Access Compliance Report

Public Rights-of-Way

(Curb Ramps)

Intersection ID: 10029624	Main Street: KING LOUIS CT	Cross Street: N/A	Location: NW
ADA ID: FF98D998DA42	Ramp Type: PerpDiag	Initial Pass/Fail: Fail	Overall Compliance: No
			Severity Score: 36.25

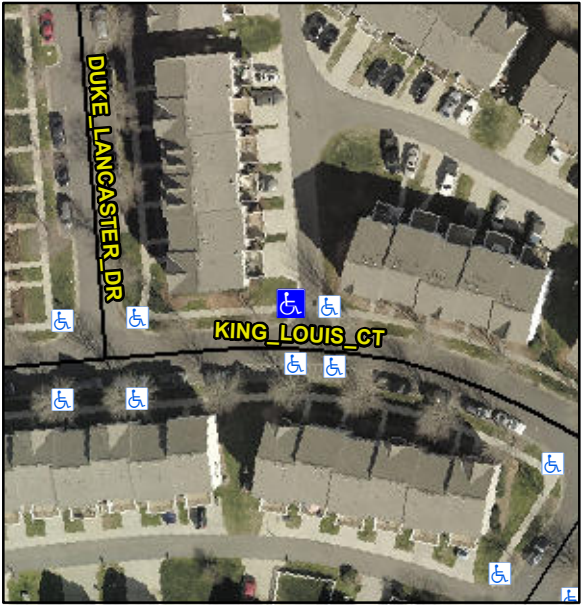
Codes/Mitigation Info/Possible Solution			Field Measurements/Component Compliance			
	Possible Solutions:		Compliance	Description	Data	
	Remove & Replace Curb Ramp With Two New Directional Ramps or Equivalent.		N/A	Ramp Length (in)	64.0	Yes
			No	Ramp Width (in)	25.0	No
			N/A	Flare Type LT	N/A	N/A
			N/A	Flare Slope LT (%)	N/A	N/A
			N/A	Flare Traversable LT?	N/A	N/A
			N/A	Landing Length (in)	N/A	N/A
			N/A	Landing Width (in)	N/A	N/A
			N/A	Landing Slope (%)	N/A	N/A
			N/A	Landing X Slope (%)	N/A	N/A
			N/A	Landing Curb? (Y/N)	N/A	N/A
			N/A	Shared Landing?	N/A	
			N/A	Gutter Ponding?	N/A	N/A
			N/A	Gutter Lip Ht (in)	N/A	N/A
			N/A	Painted X Walk1?	No	N/A
				X Walk 1 Direction	To S	
			N/A	X Walk 1 Width (in)	N/A	N/A
				X Walk 1 Slope (%)	0.1	
				X Walk 1 X Slope (%)	1.6	
			N/A	Ramp inside XWalk1?	N/A	N/A
<p>Surveyor Notes:</p> <p>N/A</p> <p>PROW/ADA:</p> <p>Not Found, R304.5.1, R304.5.3</p>				Description	Data
